# UNITED STATES PATENT AND TRADEMARK OFFICE

<b>Office Action Summary</b>	Application No.	Applicant(s)	
	10/761,031	WHEELER ET AL.	
	Examiner	Art Unit	
	Jason Prone	3724

## DETAILED ACTION

Appendix A

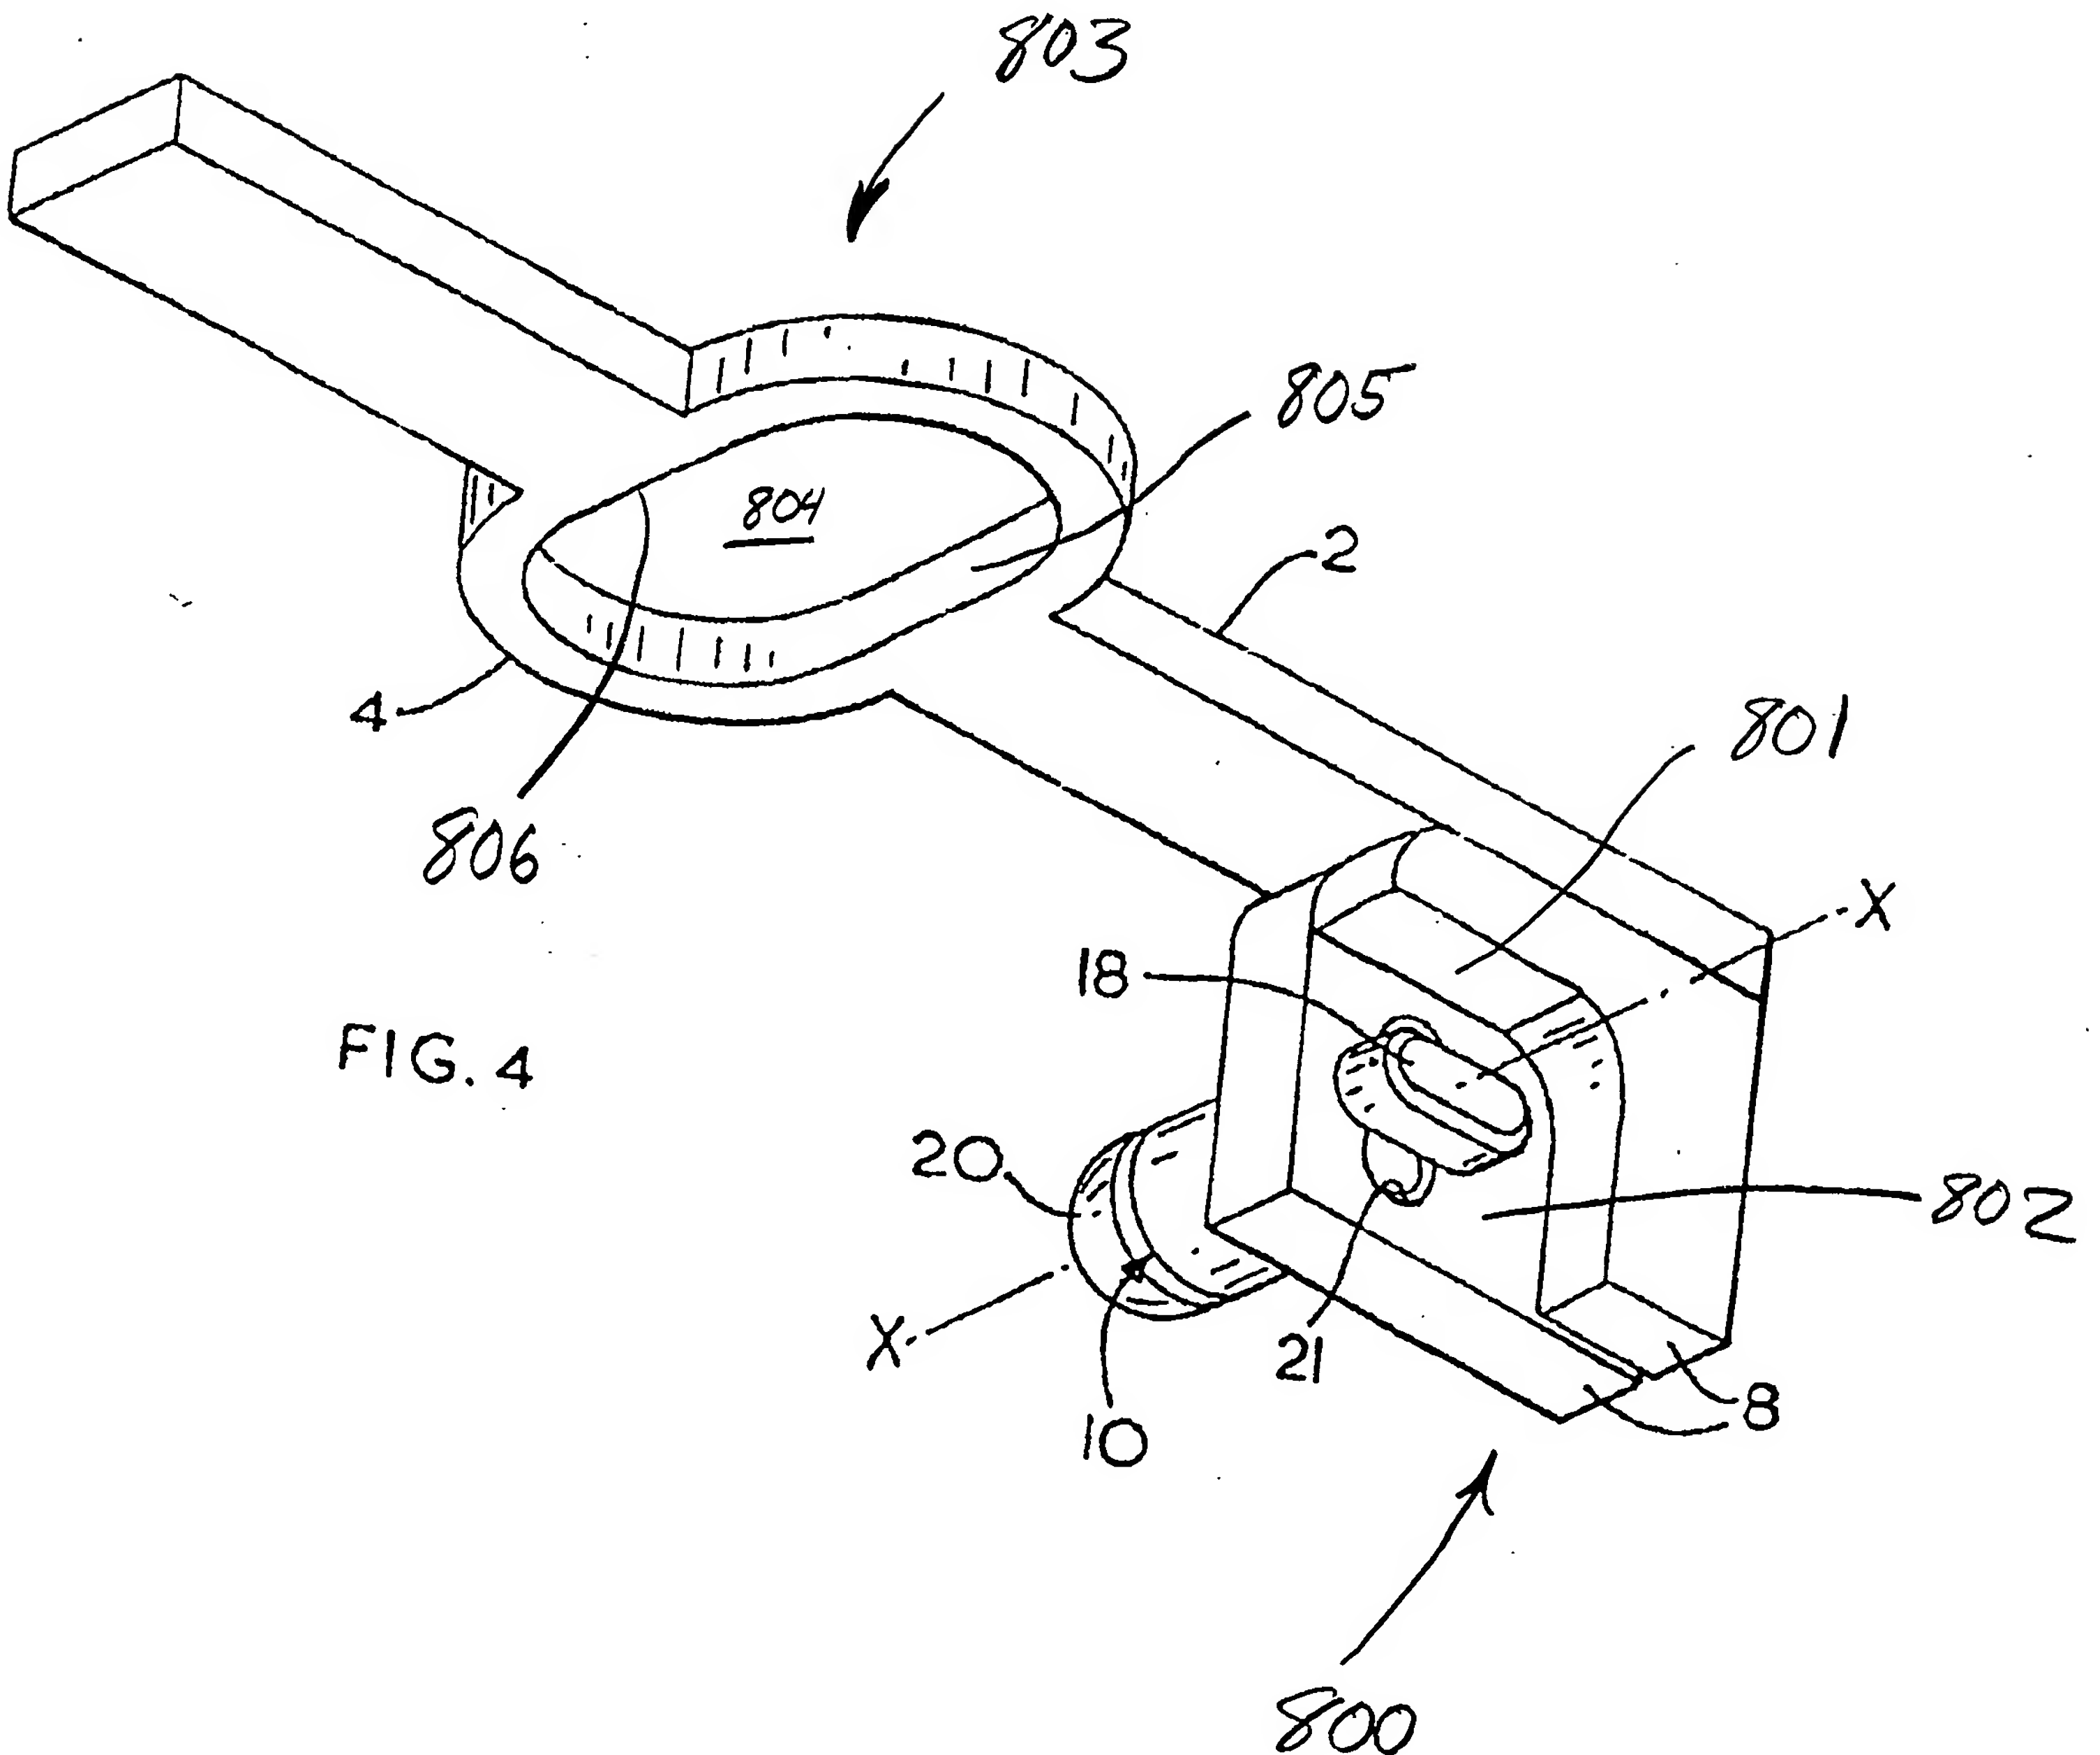
11. Claim 1 is rejected under 35 U.S.C. 103(a) as being unpatentable over Wright (6,694,625). Please see Appendix A for examiner added reference numerals.

Wright discloses the invention including a housing (36) containing a motor (24), a substantially flat planar monolithic one piece carrier slidably disposed within the housing (2), the carrier including a first portion (800) with a planar base (801) and side walls extending from and continuous with the planar base defining a channel adapted to receive a blade (802, Fig. 5), a second portion continuous with the first portion forming a one piece carrier (803), the second portion having a slot (804) with lateral side walls extending from opposing edges of the slot forming an opening through the carrier (805, 806), the carrier positioned in the housing such that a plane of the base is in a line of cutting with the saw blade so that the plane of the line of cutting is substantially parallel to the plane of the planar base (Fig. 5), a rotatable element fixed for rotation about a support and rotated by the motor (30), a follower for interconnecting the carrier and the

13. Claim 11 is rejected under 35 U.S.C. 103(a) as being unpatentable over Wright. Please see Appendix A for examiner added reference numerals.

Wright discloses the invention including a housing (36) containing a motor (24), a saw blade having a cutting edge, a mounting edge, and a side surface (12), the side surface defining a first plane in a line of cut with the cutting edge (Fig. 5), a monolithic one piece carrier (2) including a first portion (800) defining a channel adapted to receive a blade (802, Fig. 5), the channel including a base defining a second plane (801) and walls extending from and continuous with the base and substantially perpendicular to the second plane (8), the first plane is parallel to the second plane and the first plane is resting on the second plane (Fig. 5), a second portion continuous with the first portion forming a one piece carrier (803), the second portion having a slot (804) with lateral side walls extending from opposing edges of the slot forming an opening through the carrier defining a path (805, 806), a rotatable element rotated by an output shaft extending
